## CITY OF FISHERS AGENDA

**BOARD/COMMISSION: Planned Unit Development (PUD) Committee**

# Planned Unit Development (PUD) Committee Staff Report

PUD-25-17

**Elevations**

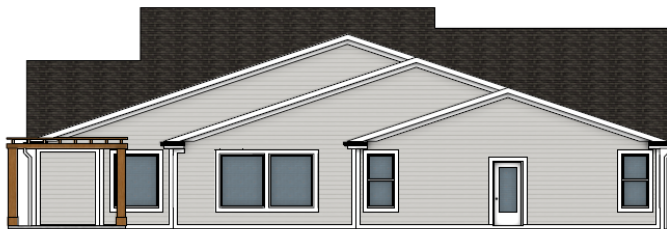
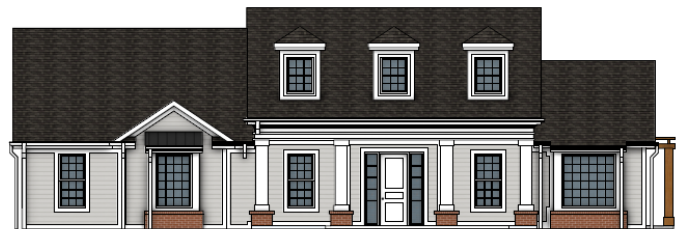
The two sections **highlighted in yellow** are areas where staff allowed a deviation from the UDO standards. See below.

- 1) Section 6.3.5.B.2.e. states that buildings facing local and collector roadways, off-street parking must be located to the side of or behind buildings with only one (1) row of off-street parking in front of the building façade.

Due to the narrow site constraints, a side driveway with rear parking is not feasible.

- 2) Section 6.3.5.C.2.b. states qualifying modulation must be at least 12” in depth, be at least 14” in width or height (whichever is narrowest), and occur in total for 20% of overall façade elevation. For buildings with façades less than 100’, horizontal modulation must occur no less than every 30’. For buildings with façades greater than or equal to 100’, horizontal modulation must occur no less than every 50’.

Modulation on the west, south, and east elevations meet this standard, however, a drainage swale along the northern property line prevents modulation from occurring.

Staff recommends approval on the condition that all TAC comments are addressed before final approval is given.

*South Elevation (Lisbon Lane)*

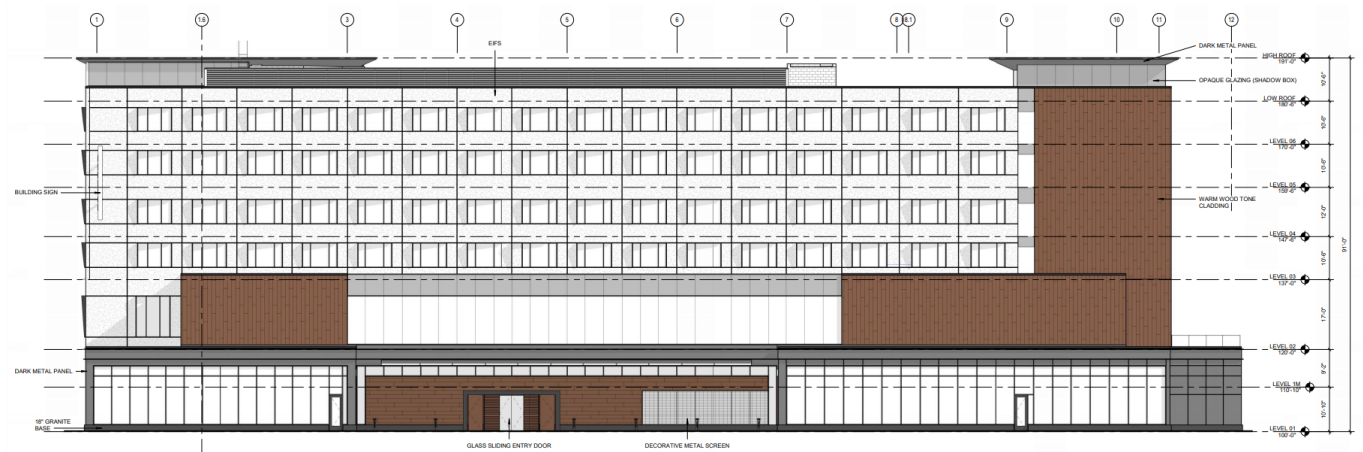
Staff continues to have concern with the southwest corner of the building. Staff believe the petitioner should continue to work to identify a way to provide additional architectural interest through a combination of pedestrian scale awnings / overhead, additional modulation and/or a creative sign package.

**Staff recommends Approval with the Condition that the petitioner continues to work with staff on identifying and updating the elevations once a solution is found for the southwest corner.**

**ELEVATION**

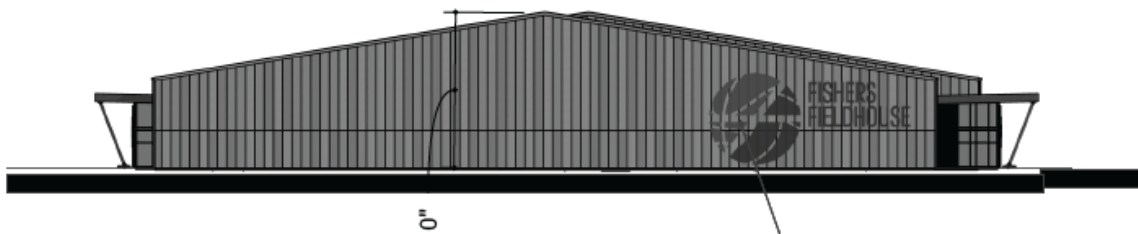
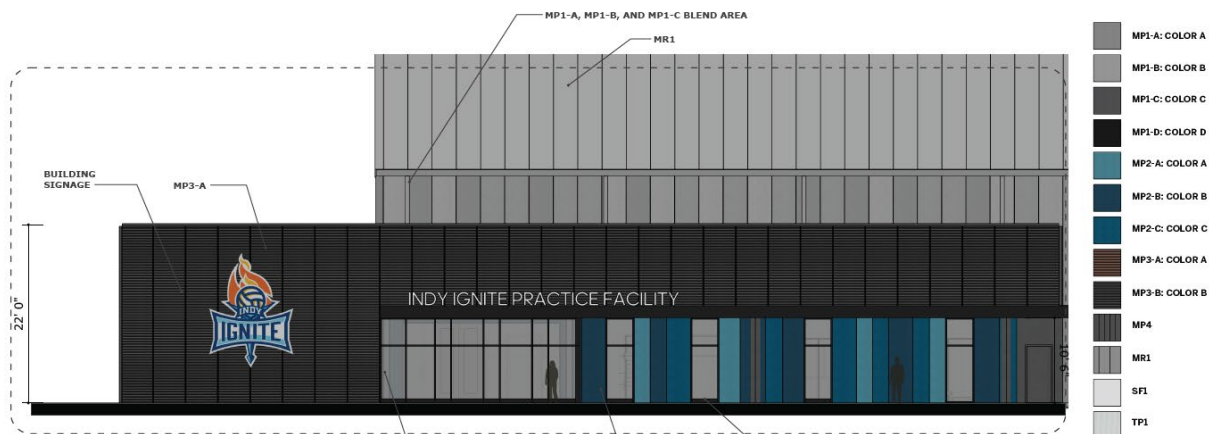
Staff will continue to work with the petitioner on HVAC screening solutions while parking lot, landscaping and buffering will all be handled through the Technical Advisory Committee (TAC) process via the associated Improvement Location Permit (ILP).

The building footprint and elevation for IU Health are not shown with these elevations. Staff recommend the IU Health portion have the same look and feel, including building modulation, and similar material including window glazing and awnings to be a harmonious addition.

**Staff recommends Approval with the Condition that the petitioner continues to work with staff on HVAC Screening, Landscaping, Buffering and Parking, and the IU Health Elevations.**
